## CMF Industrial CMF50, CMF55, CMF60, CMF65, CMF07, and CMF20.

**Description of Change:** This only applies to the Industrial components only. Change of manufacturing location and component specifications. Changes may include, but are not limited to the following: Tolerances, Temperature, Values, TCR, Operating Voltages, Component Color, and mechanical specifications. All options will now only be lead (Pb) free. Please refer to the attached tables for changes and data sheet for specifications.

# Product Change Notification

Product Group: DR/Fri May 31, 2024/PCN-DR-00005-2024-REV-0

**LOAD LIFE SHIFT DUE TO POWER AND DERATING AT +70 °C**

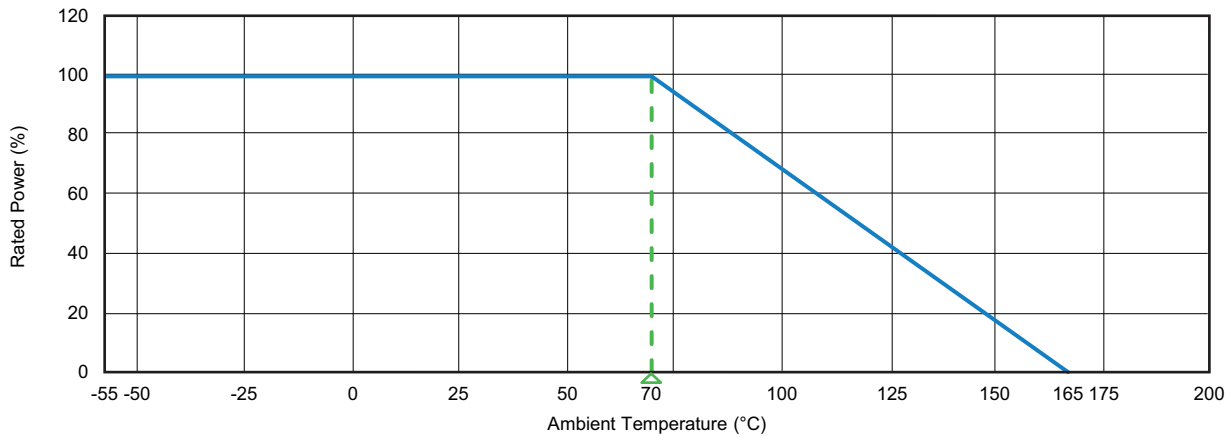
The power rating for the CMF parts is tied to the derating temperature, the heat rise of the parts, and the  $\Delta R$  for the load life performance. When the tables/graphs below are used together they show that when the parts are run at their higher power ratings, the parts will run hotter, which has the potential of causing the resistance of the parts to shift more over the life of the part.

LOAD LIFE SHIFT VS. POWER RATING			
LOAD LIFE	MAXIMUM $\Delta R$ (TYPICAL TEST LOTS)		
	$\pm 0.15\%$	$\pm 0.5\%$	$\pm 1.0\%$
MODEL	POWER RATING AT +70 °C		
CMF50	1/10 W	1/8 W	1/4 W
CMF55, CMF07	1/8 W	1/4 W	1/2 W
CMF60, CMF20	1/4 W	1/2 W	1 W
